(8) PART NAME: ZBOM		(9) PART/DWG NO.: 39532-D-3100			(10) REV: B
(11) CLASSIFICATION: (PRIORITY) Major	(12) LOCATION: EMS Tupelo	(13) HWCI NO. AND NAME: 39532-D-3105-2 - THERMAL BRIDGES, OD, PS2

Subject: RE: QN 7071839 - Damaged thermal bridges - PS2 Coil Assembly, for FNAL review and concurrence.

Thermal Bridges (TB)

- **Reference: PS2 Damage to Thermal Bridges-1.pptx 09/09/20 presented by Paul Clark**
- **Reference: PS2 TB Damage.pdf 09/11/20 by Jonathan Miller**
- **This presentation is in support of QN 7071839 (Damage to 24 Outer Diameter TB's on the lead end of PS2)**

Bending Test

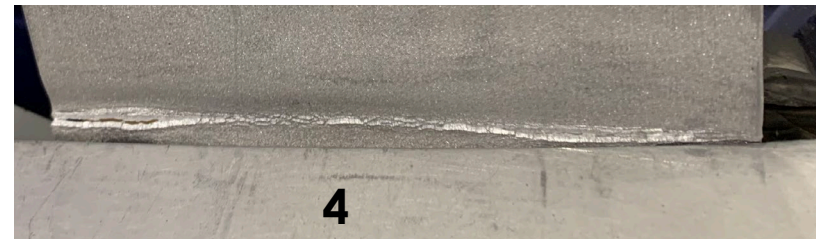
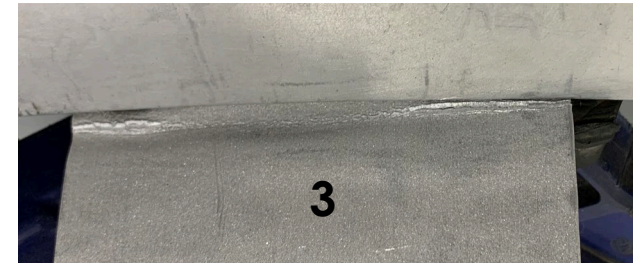
- A strip of thermal bridge (worst case/grit blasted) was put into a vise and dented with a chisel covered by a cloth and a plastic head mallet... to best duplicate the dents seen on PS2 thermal bridges.
-
- The dented strip was then clamped to the ID of a DS mold and bent 90° over the edge of the mold by tapping it with a plastic head mallet until it was flat against the edge. A plastic block was also used afterward to flatten out any kinks or projections on the back of the thermal bridge.
- The thermal bridge was then raised back to vertical and lowered back to horizontal (a “full bend”) a number of times until a crack first appeared and finally until it broke entirely.

- **Most damaged thermal bridges began to crack after 7-8 “full bends” and to fully break around 13-17 full bends versus the control sample which lasted longer before breaking in two. One particularly damaged one had a crack at 4 bends, cracked through to the back at 7 bends, and broke fully at 10 bends.**
- **The work hardening from the flexing seemed to lead to final breakage of the parts more so than the dents (unless extreme). Any bending of the thermal bridges during assembly should be minimized as much as possible.**

TB#5 after forming

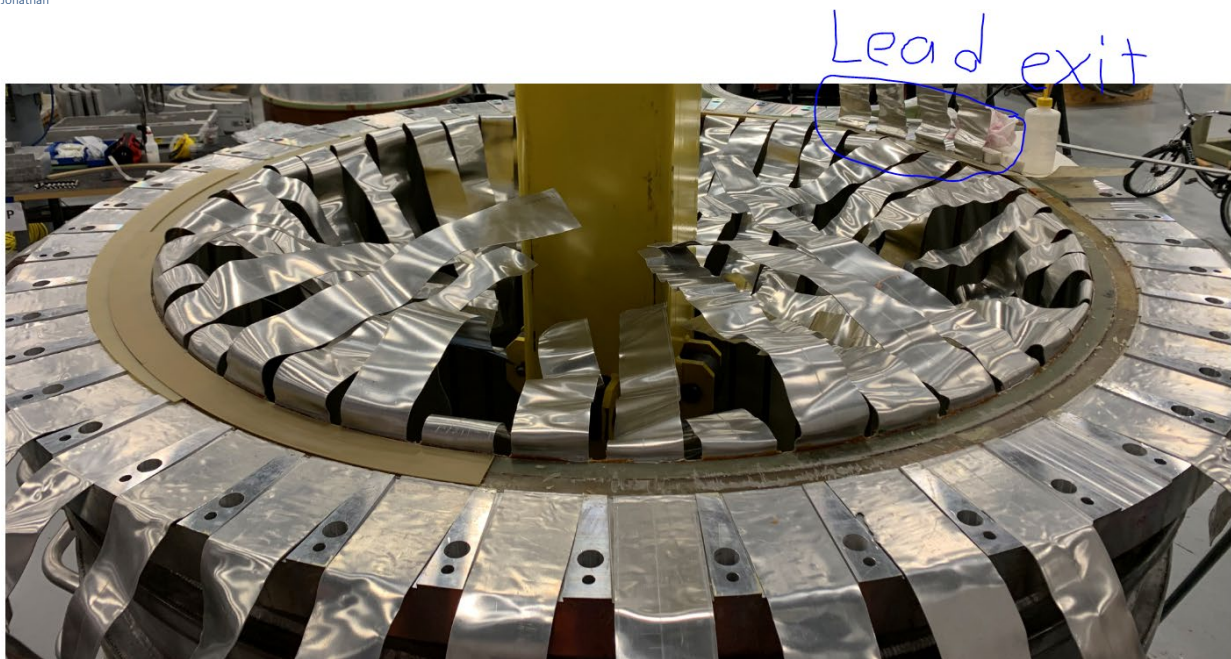
TB# 5 does have a small surface crack on the O.D. of the bend. It still feels "secure" not loose. Also, after reviewing the before pics it appears that this is not a new crack and was present before being formed into the slot.
